## Ordering the New Software

Remote Link and System Link updates version 1.40 are available for download free of charge on the DMP Dealer Direct Website at <http://dmp.com/dealer>. Hard copy updates on CD can be obtained at [buy.dmp.com](http://buy.dmp.com) or by calling DMP Customer Service at 1-800-641-4282.

## Delete User Codes

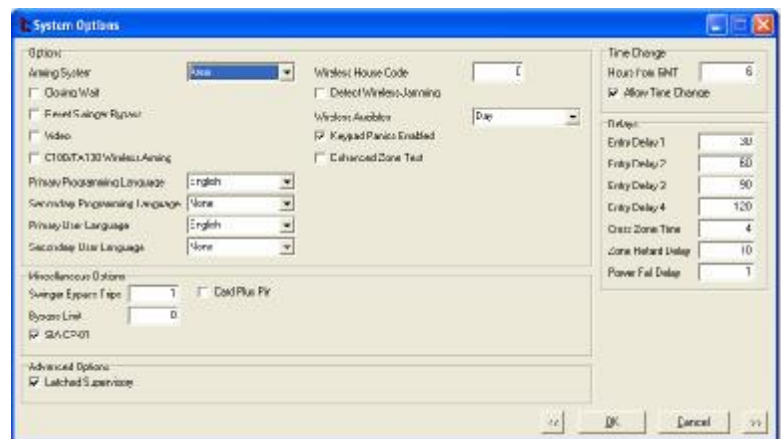
To delete User Codes from the panel file, select the Delete tab.

Click on the check box next to the user code to delete, or **Select All**. When selection is complete, click **Delete**.
